Monticello Nuclear Generating Plant
Docket No. 50-263
Renewed Facility Operating License No. DPR-22

Part 3 Response to Probabilistic Risk Assessment (PRA) Related Requests for Additional Information: License Amendment Request for a Permanent Extension of the 10 CFR 50 Appendix J Containment Type A Test Interval (CAC No. MF7359)

**PART 3 RESPONSE TO PROBABILISTIC RISK ASSESSMENT (PRA) RELATED
REQUESTS FOR ADDITIONAL INFORMATION**

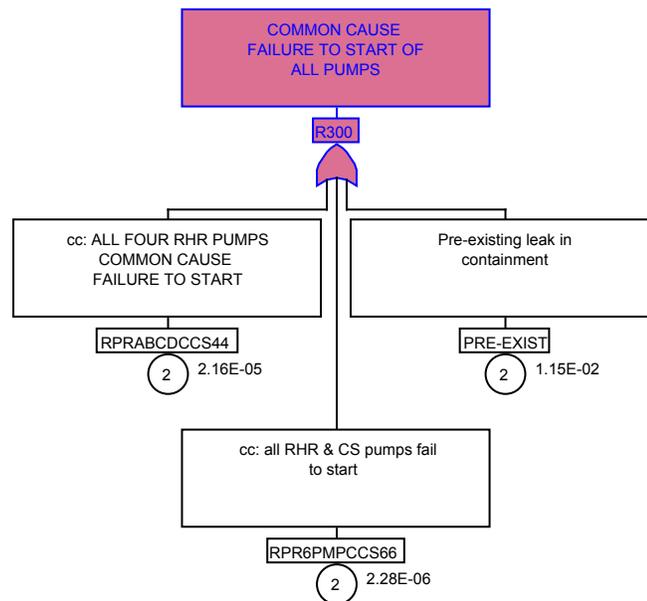
- b. **If an updated analysis is performed, describe this analysis and justify why it is sufficient to evaluate the risk due to the containment accident pressure for the application.**

Response to RAI 4b

The second step in the analysis is to add a new basic event to the MNGP PRA model to logically OR the pre-existing leak basic event with the low pressure ECCS pumps, such that the pumps are failed when the leak occurs. The basic event is logically ORed with the basic events that model a common cause failure of all Residual Heat Removal (RHR) and Core Spray pumps. An example is shown below:
